**PLANNING COMMISSION MEETING AGENDA
OCTOBER 4, 2022
6:00 PM**

Large Scale Development Plan: Freeman Family Rentals

Re: Conditional Approval of Civil Plans
Freeman Family Rentals

Site Plan	Sheet reference number: C-103	Sheet of 15
-------------------------	---	--------------------

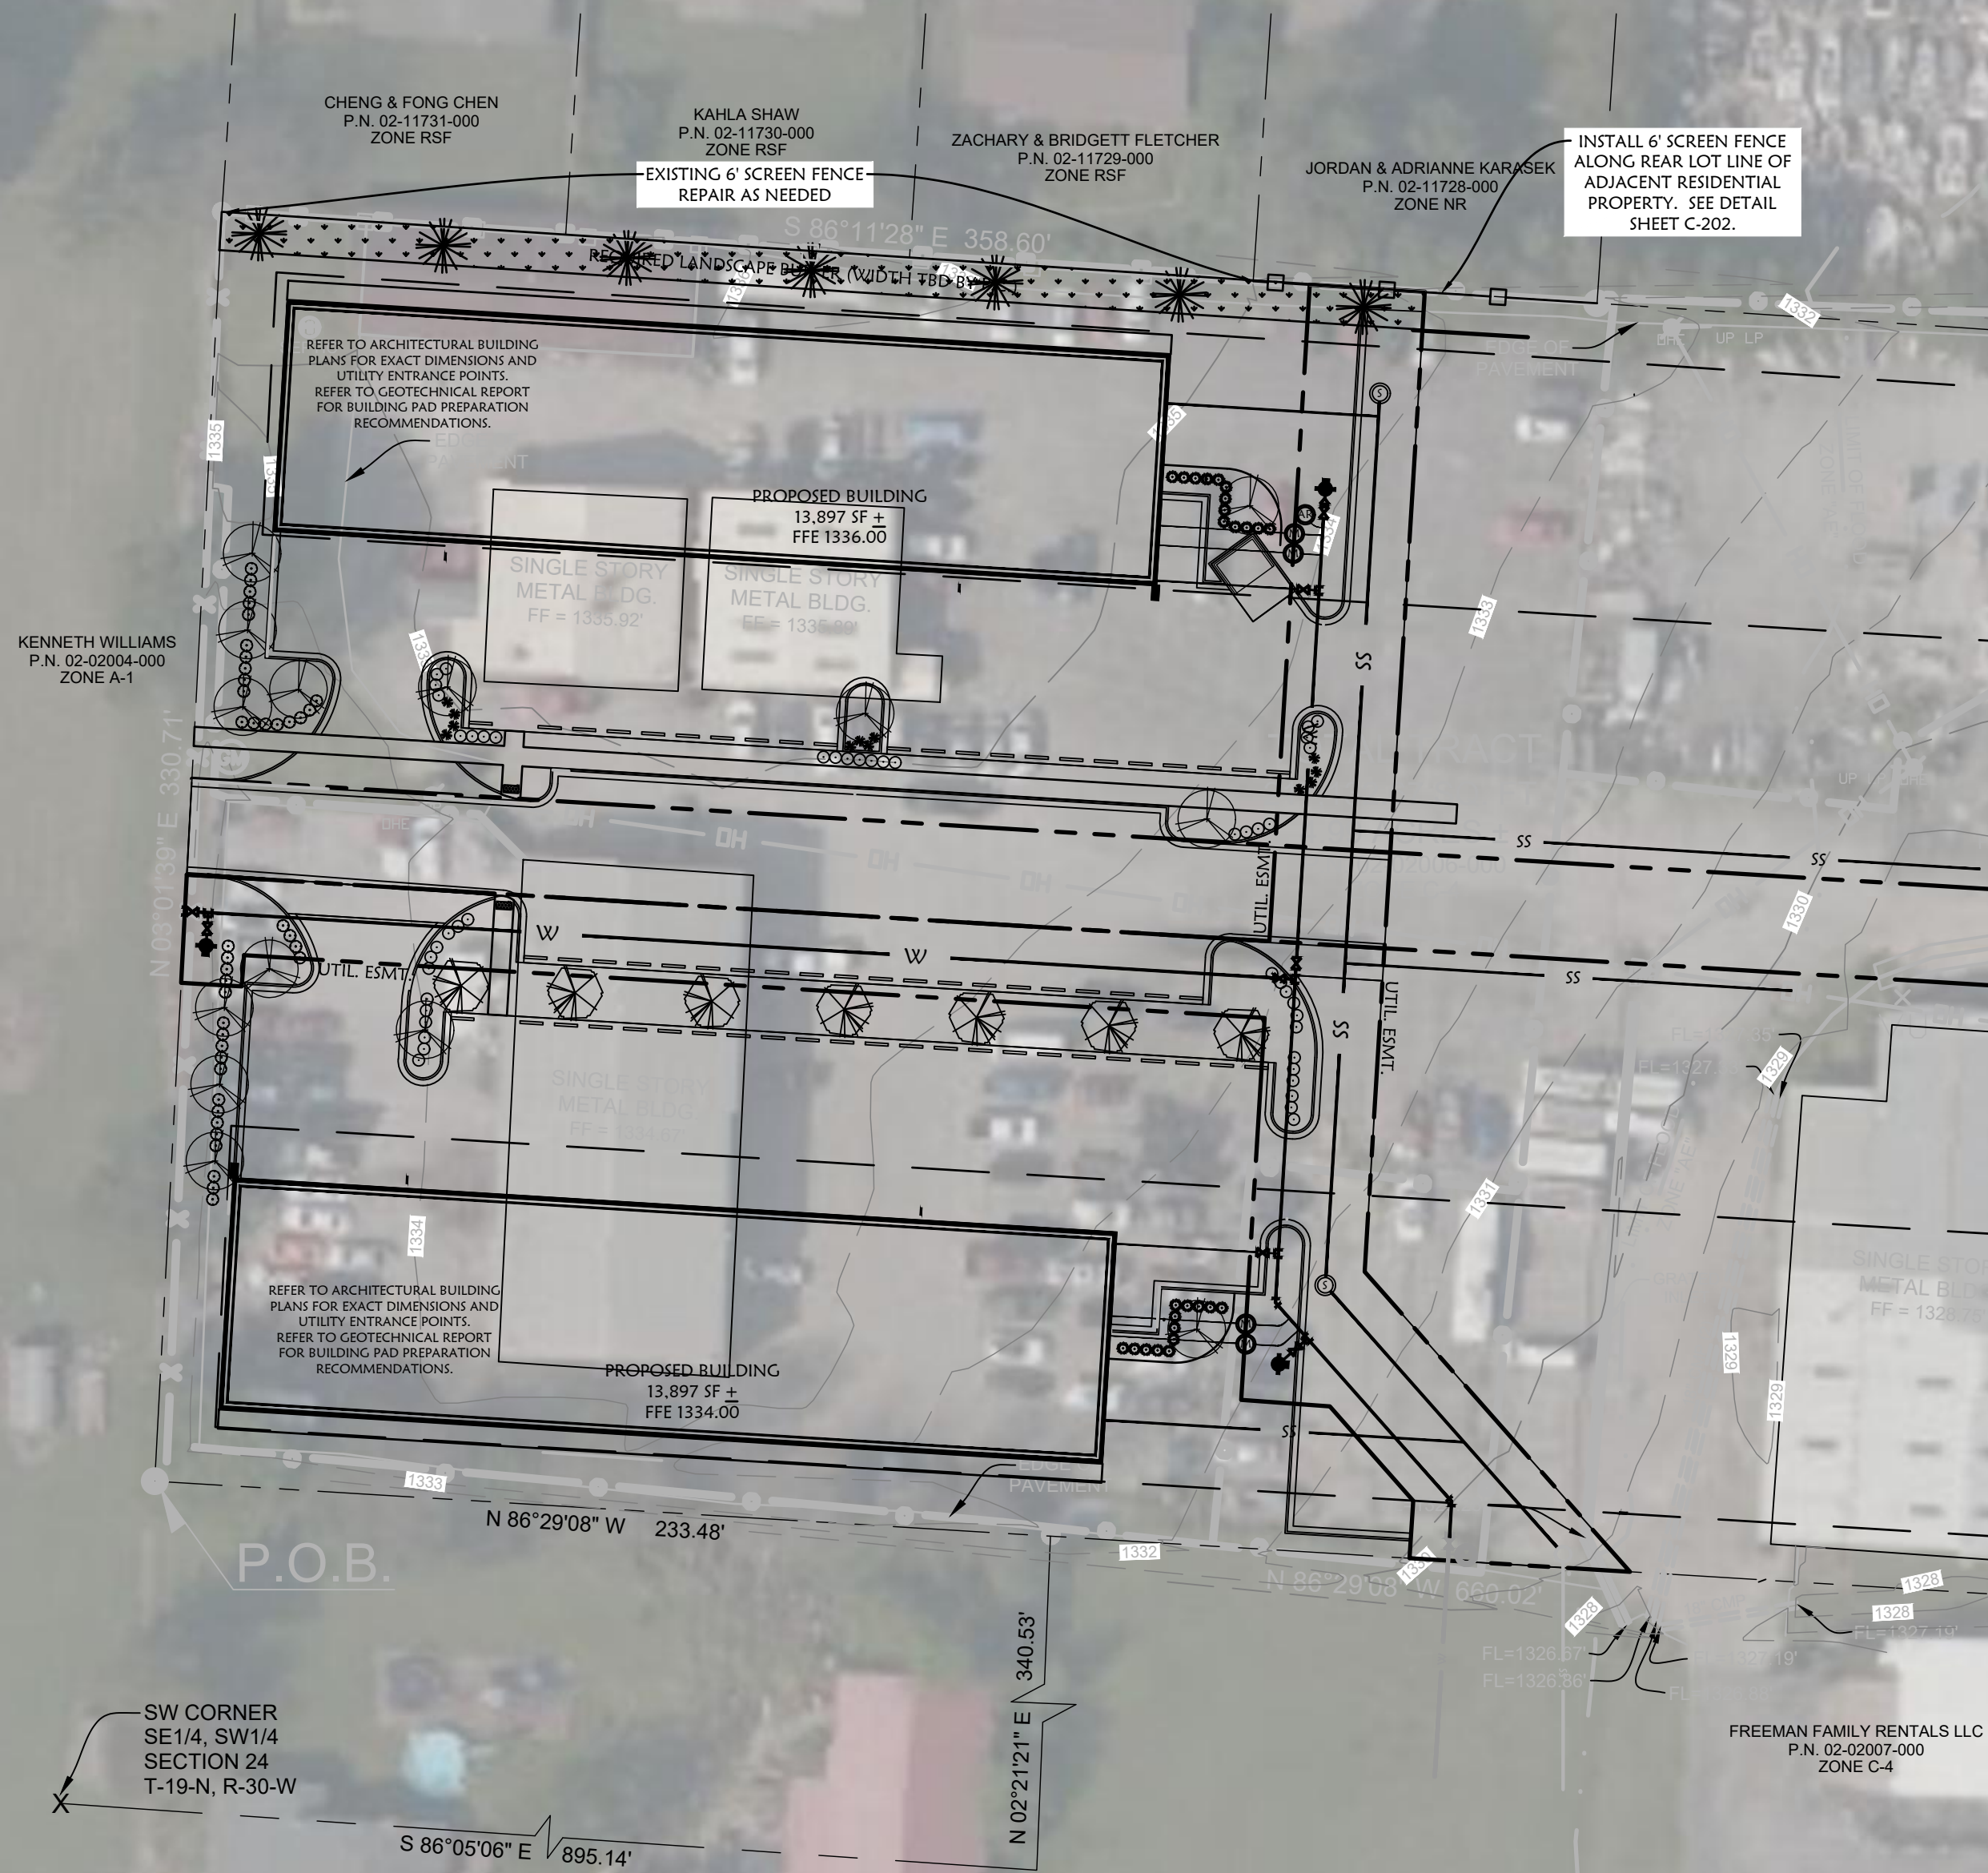
- Trails:
 - Trails are not proposed nor required.
- Streetlights:
 - A streetlight is being proposed at the corner of the driveway providing access to 8th Street. Additional streetlights along what will be dedicated as Bonnie Lane will need to be called out on the plans every 200-feet.

Landscaping Plan

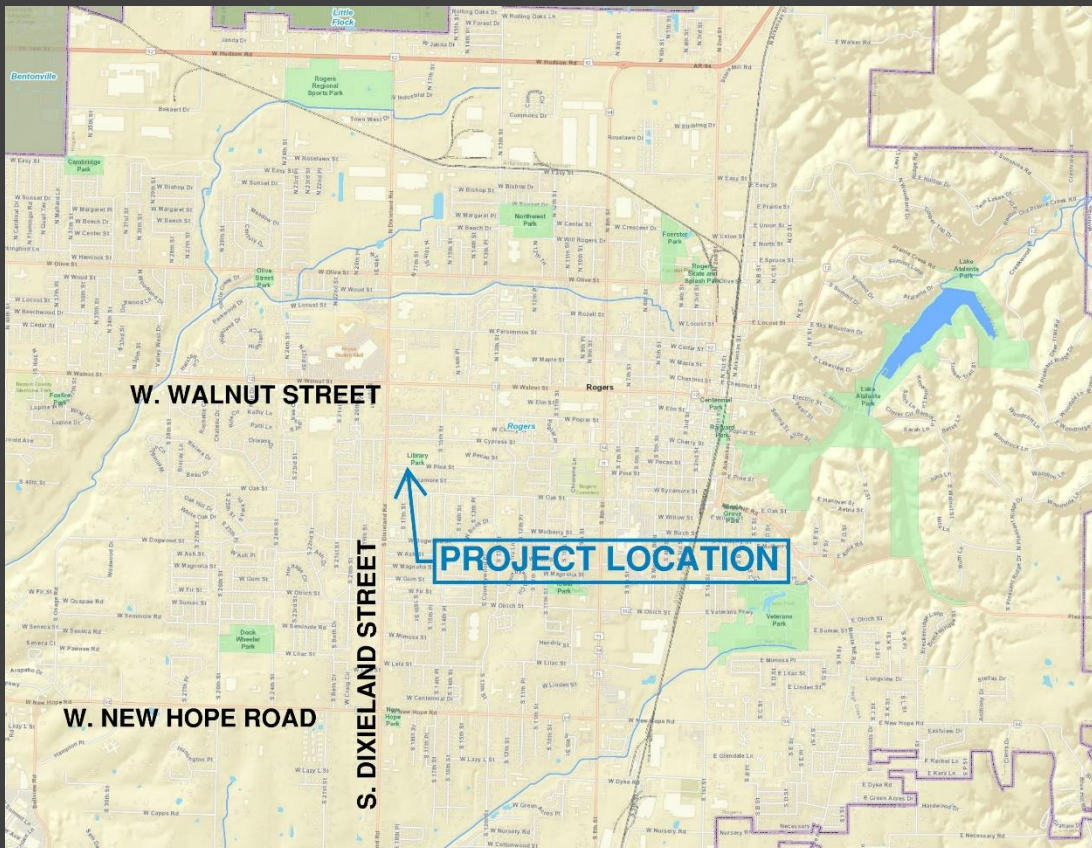
1. Show the location and size of an irrigation meter and RPZA. An irrigation meter is required since there is a Landscape Plan. Otherwise, our crews almost invariably have to schedule time to install a service once the landscaping gets done.

5. The grid elevation and horizontal station numbers are still difficult to see on the profiles. It appears the text shading is too light.
6. Large Trees (over 20' tall at maturity in City Code 14-46-paragraph G) must be located at least 10 feet from any water or sanitary sewer main. There are three red maples on the Landscape Plan that are shown less than 10' from Water Main 2 that will be in violation of this code.
